**MINUTES  
TOWN OF DARIEN  
BOARD OF SELECTMEN  
REGULAR MEETING**

**August 4, 2014**

## MEMORANDUM

RE: Goodwives River Floodplain Modeling and Mapping  
Hamilton Lane Area  
Darien, Connecticut  
MMI #1581-05-7

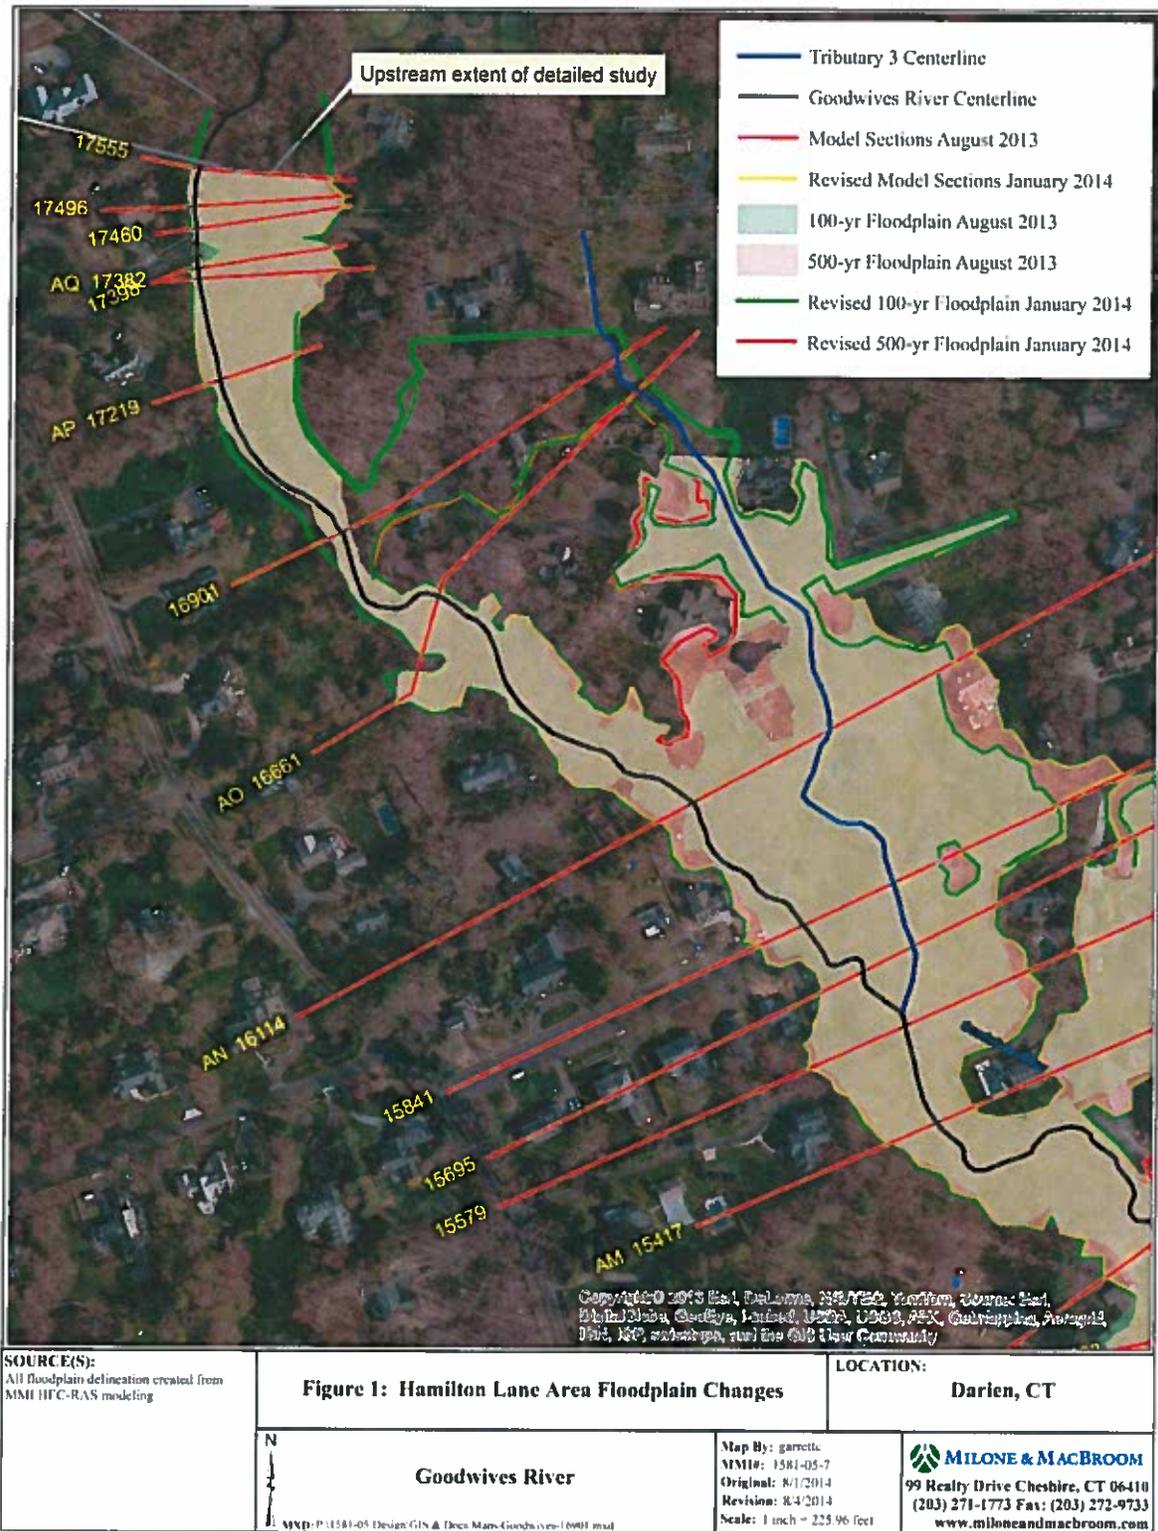
The Town of Darien via MMI first submitted the updated study information to FEMA for review in August 2013. FEMA reviewed the application materials and on September 12, 2013 returned comments and asked for some revisions. Among its comments, FEMA specifically asked: "Please add more cross sections in areas where there is a change in channel geometry, such as between cross sections 17219 and 16661." FEMA provided specific guidance, stating that cross sections must be drawn perpendicular to the contours and flow line and must not contain multiple bends. MMI added cross section 16901 (immediately upstream of Hamilton Lane) to the model at that time. This cross section was developed using available channel data and topographic data from the Sewall mapping.

Through its comments, FEMA dictated the way cross section 16901 is drawn across the floodplain and prompted the left overbank (when facing downstream) portion of the cross section at river station 16661 to also be adjusted in the Hamilton Lane area.

Cross section 16901 provided critical additional detail at a location where the river channel is narrow. The additional detail dramatically changed the extent of the floodplain in this area. Figure 1 shows the Hamilton Lane area floodplain boundaries as submitted to FEMA in August 2013 and the revised floodplain following the addition of cross section 16901 in January 2014. FEMA reviewed the modifications to the model and mapping and ultimately approved the submission.

Goodwives River at station 16901 is not large enough to carry the entire 100-year or 500-year flow. This is common in river systems and is why floodplains exist. FEMA modeling protocols require that cross sections extend across the floodplain to the point where the entire flow is contained within the floodplain. In the case of cross section 16901, the cross section must extend across the floodplain at Hamilton Lane to include Tributary 3. This extends the 100-year and 500-year floodplains to include that area of the overbank near Hamilton Lane as shown on Figure 1 included in the floodplains labeled January 2014.
